STAFF RECOMMENDATION 218 Mockingbird Road May 18, 2016

Application: New construction—addition; Setback determination
District: Cherokee Park Neighborhood Conservation Zoning Overlay
Council District: 24
Map and Parcel Number: 10312015900
Applicant: Joan Mayhugh
Project Lead: Melissa Baldock, melissa.baldock@nashville.gov

Description of Project: Application is to construct a front, roof, and rear additions to a non-contributing house. The rear additions require a setback determination, as a portion will be situated approximately three feet, eight inches (3'8") from the right side property line.

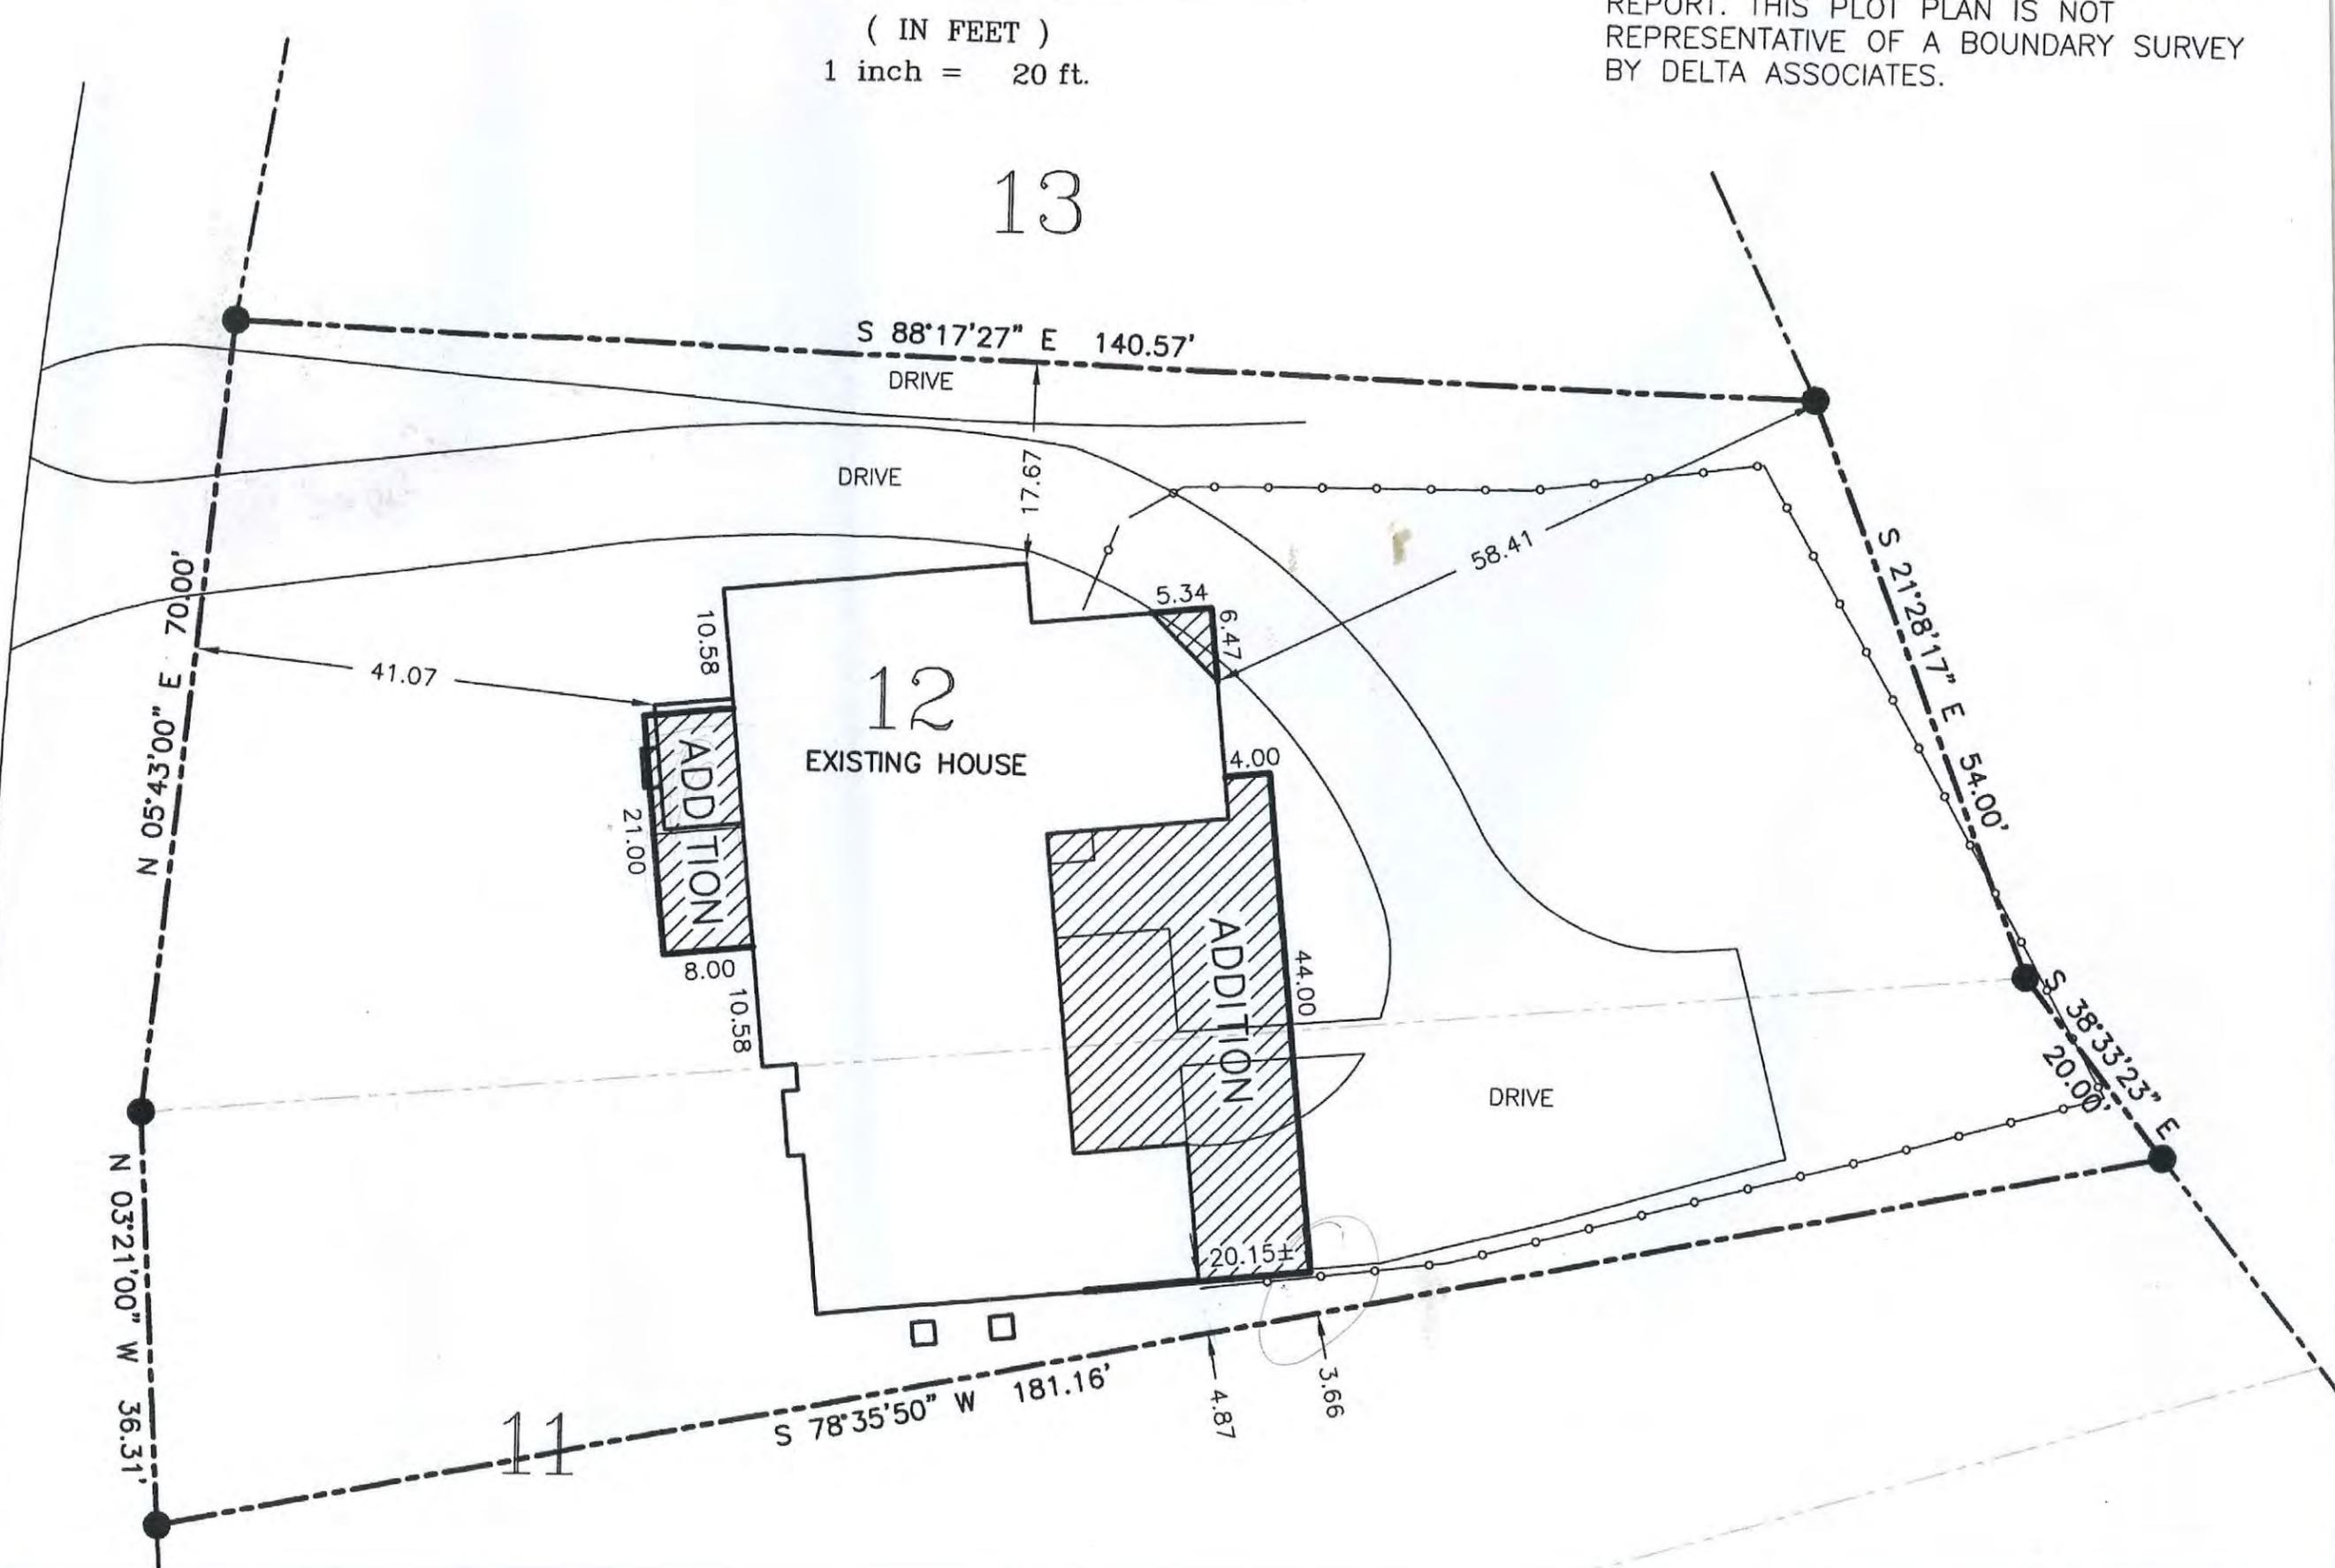
The addition does require a change to the right side setback. Base zoning requires a five

foot (5') side setback. On the right side, the right wall of the house will be extended approximately ten feet (10'), and it will continue the line of the existing wall. Because of how the house is angled on the lot and how the lot narrows towards the rear, the new addition will sit between three feet, eight inches (3'8") and four feet, ten inches (4'10") from the right side property line. Staff finds the proposed change to the side setback to be appropriate for several reasons. The addition will be no wider than the existing house, and it will only be approximately fourteen inches (14") closer to the side property line than the existing house. Its depth is relatively modest at about ten feet (10'). The house on the other side, 214 Mockingbird, is shifted away from this property line so the two structures will have appropriate spacing between them. In addition, an examination of historic Sanborn maps show that historically some houses in Cherokee Park were situated less than five feet (5') from the side property lines. Staff finds that the proposed setbacks and rhythm of spacing meet Section II.B.1.c. and II.B.2. of the design guidelines.

Front Elevation

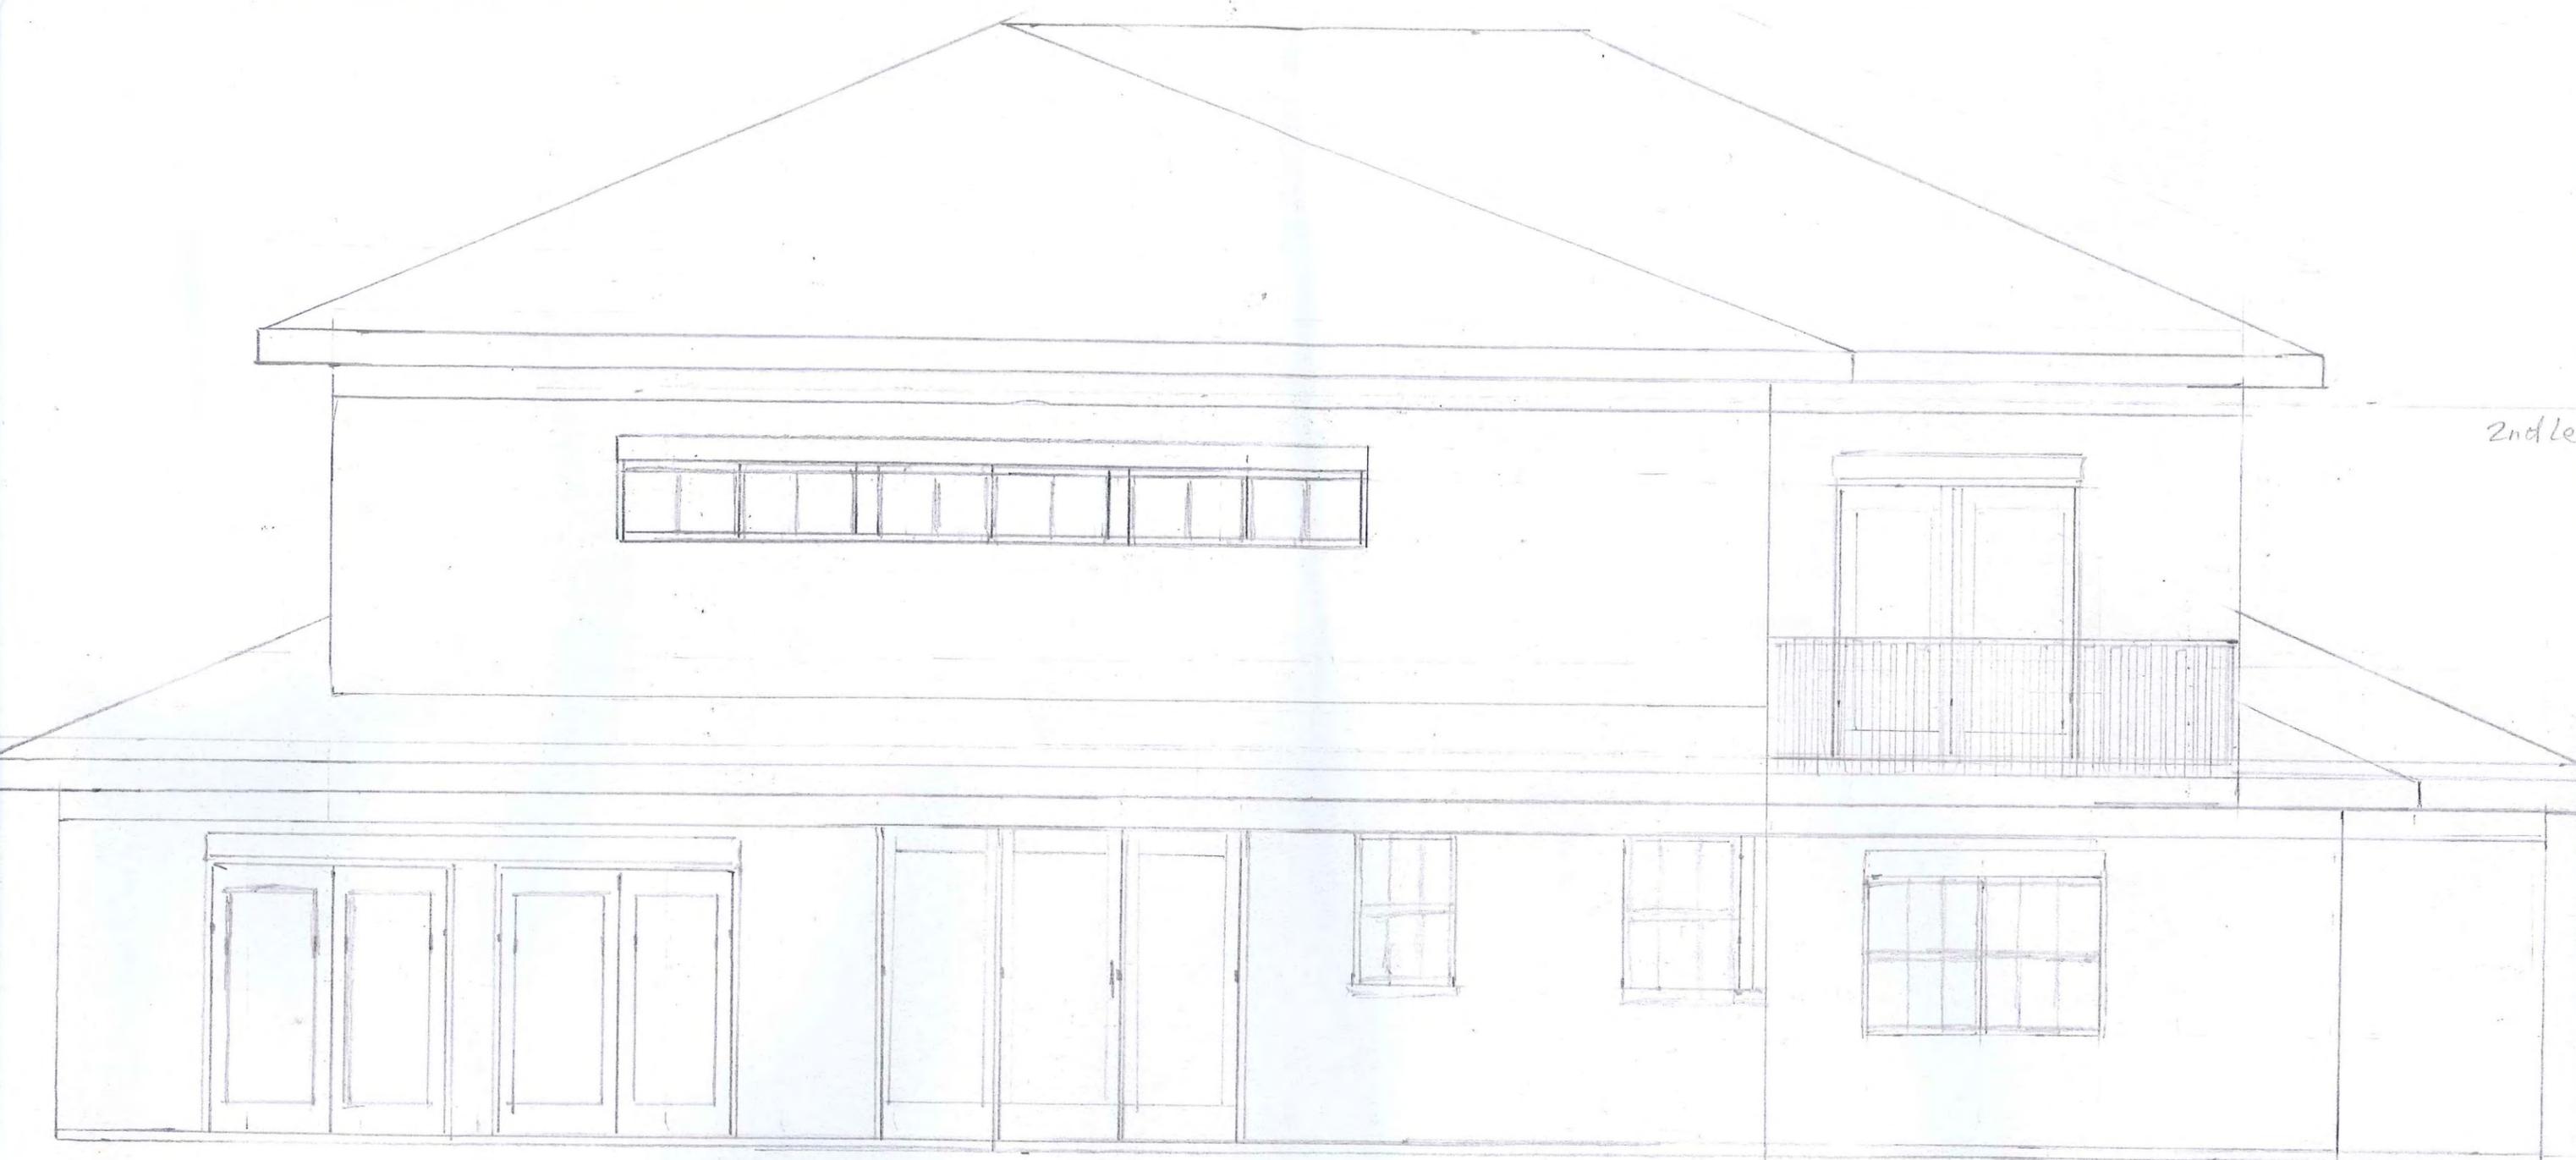
Height & Scale: The addition will alter the existing, one-story house into a two-story house. The width of the house, which is approximately sixty-four feet, three inches (64'3") will not change. Staff notes that the front façade drawing shows the house as only being approximately sixty-one feet (61') wide, whereas the other drawings and Metro Maps show it to be sixty-four feet, three inches (64'3") wide. Staff recommends that a condition of approval be that the applicant submit new drawing that show the accurate width of the house.

On the front façade, second story, the applicant is proposing two faux window openings, which will be closed up with shutters, and will also have shutters hung to the sides of them. Staff finds that faux window openings on the front façade are not appropriate and recommends that these window openings be real, glazed window openings. With this

1. The applicant submit a revised front façade drawing showing the accurate width;
2. Staff approve the final details, dimensions and materials of windows and doors prior to purchase and installation;
3. Staff approve a sample of the clay tile roof;
4. The shutters be fully operational, and staff approve their material and design;
5. The faux window openings on the front façade be made to be real, glazed window openings; and
6. The HVAC shall be located behind the house or on either side, beyond the midpoint of the house.

Right side Elevation

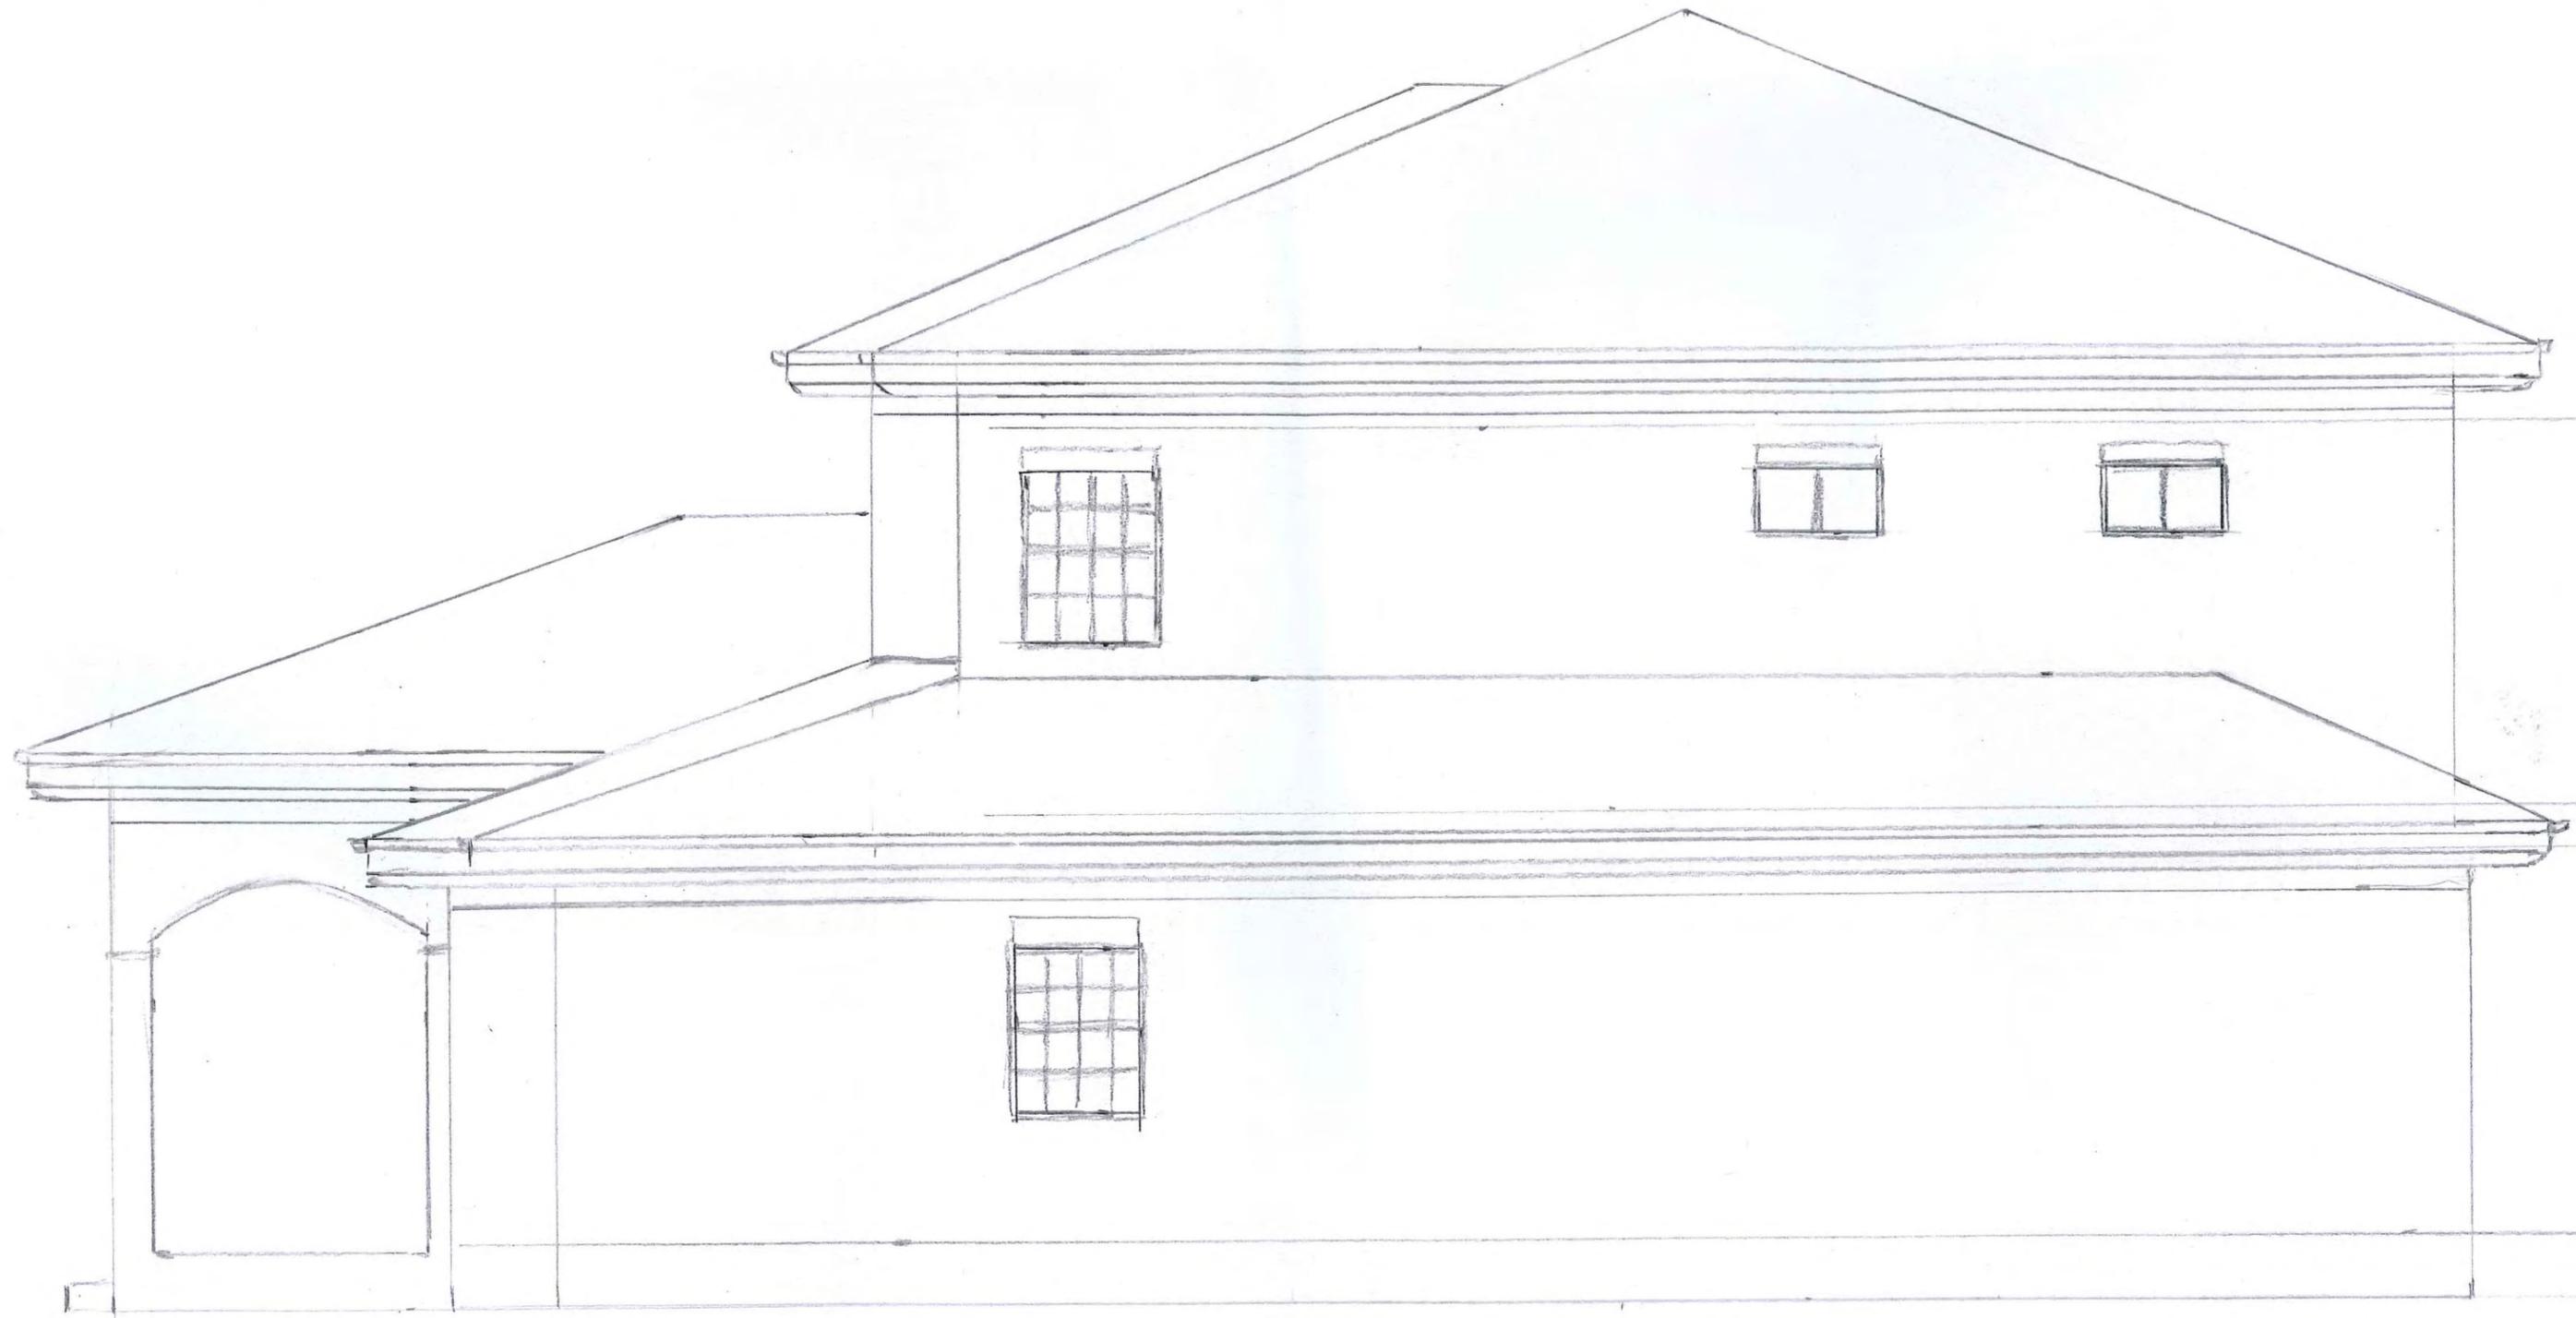
Proportion and Rhythm of Openings: The drawings indicate that the window and door openings on the existing house will not change. On the right side elevation, on the ground floor, there is a large expanse of wall space without a window or door opening. Because this wall space does not currently have a window, staff finds the proposed fenestration pattern to be acceptable.
